**PROJECT** Highway 62 Preliminary Design Study, from 5.3 km  
 north of Cleveland Road to 300 south of County  
 Road 620, including Beaver Creek Bridge  
 Replacement  
 G.W.P. 66-99-00 / 248-99-00

**Highway 62, Beaver Creek Bridge**

**Re: Response to Comments  
Draft Preliminary Foundation Investigation Report  
Hwy 62 Beaver Creek Bridge Replacement, WP 66-99-00**

SS103-12

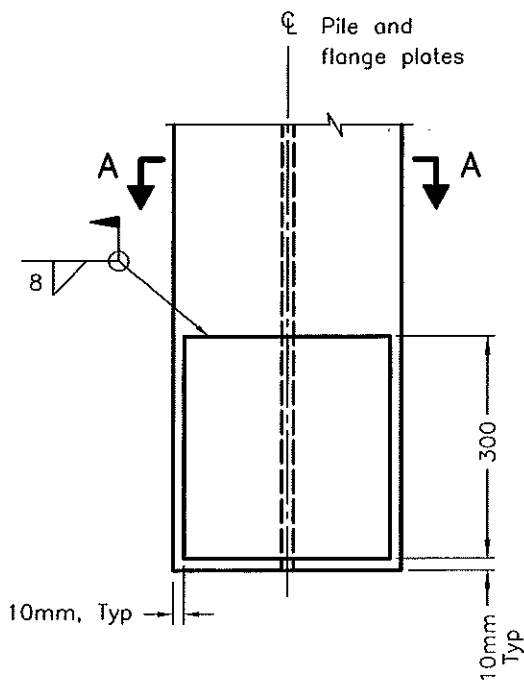
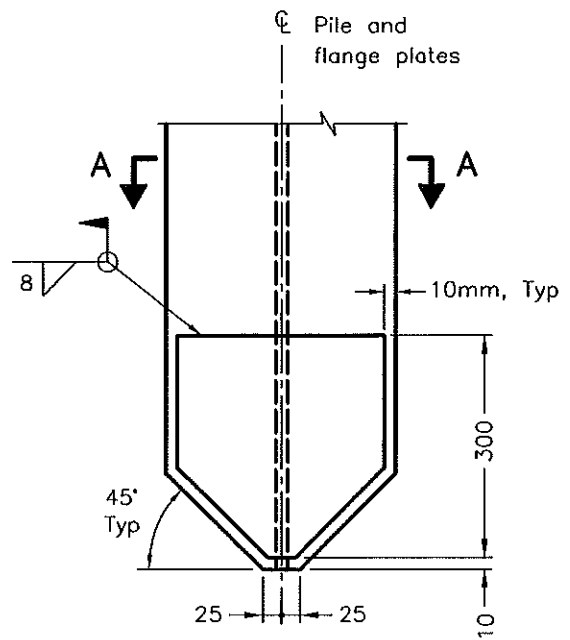
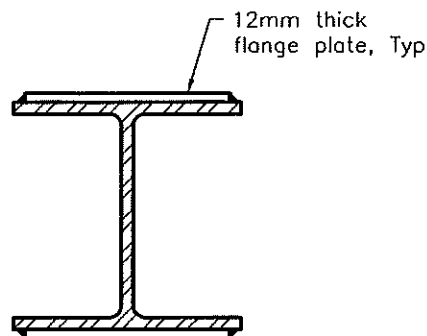
- Clarification is needed on the recommended bearing point/driving shoes. Is OPSD 3000.100 an applicable drawing in CPS? Should the standard drawing SS103-12 be referenced instead if driving shoes are being recommended? *Drawing SS103-12 (copy attached) provides details for splicing of steel H-Piles. In the absence of other applicable drawings we recommend referencing OPSD 3000.100 for Pile Driving Shoes.* ✓

OPSD - 3000.100

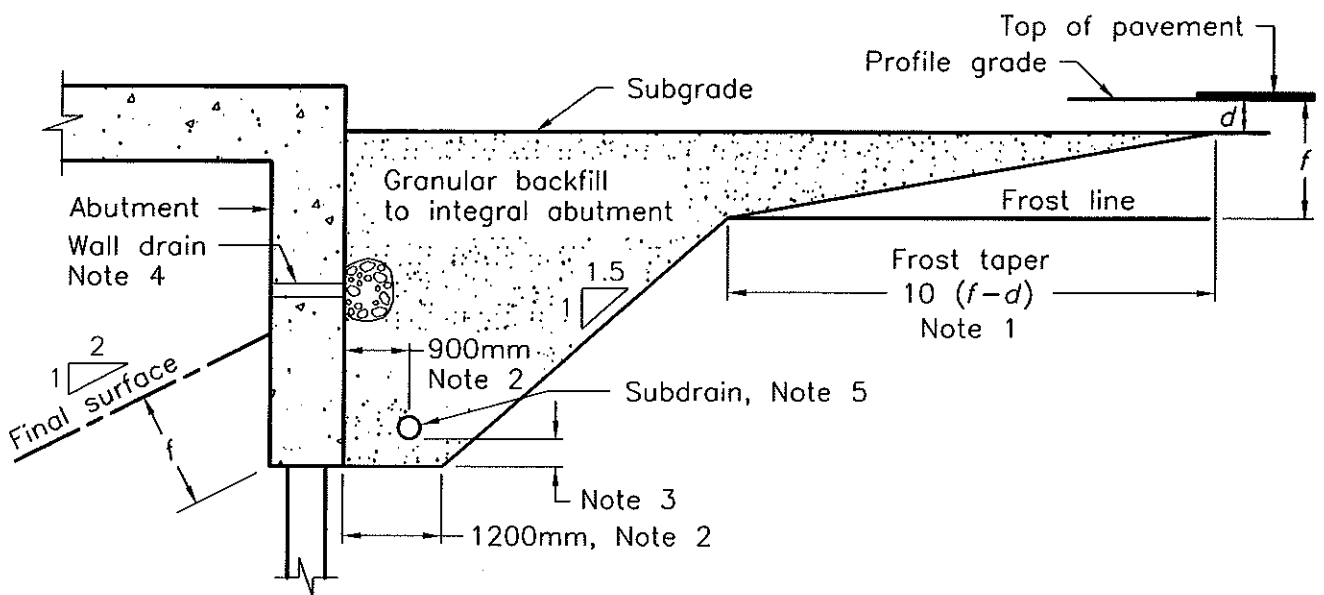
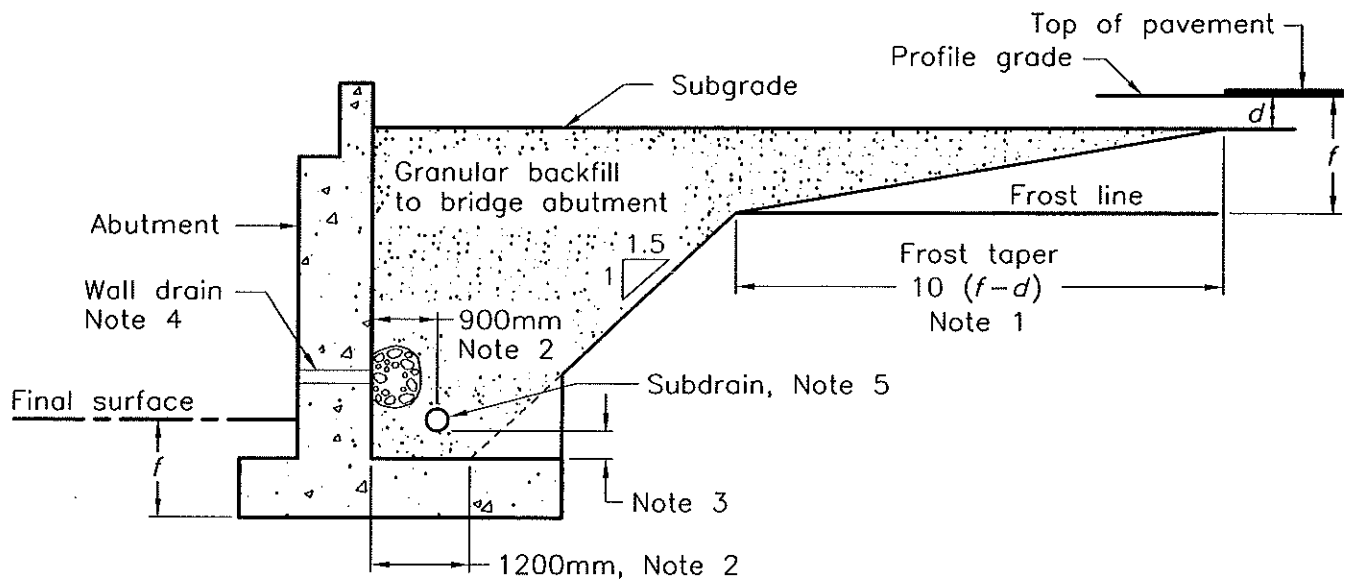
- Clarification is needed on the recommended bearing point/driving shoes. Is OPSD 3000.100 an applicable drawing in CPS? Should the standard drawing SS103-12 be referenced instead if driving shoes are being recommended?
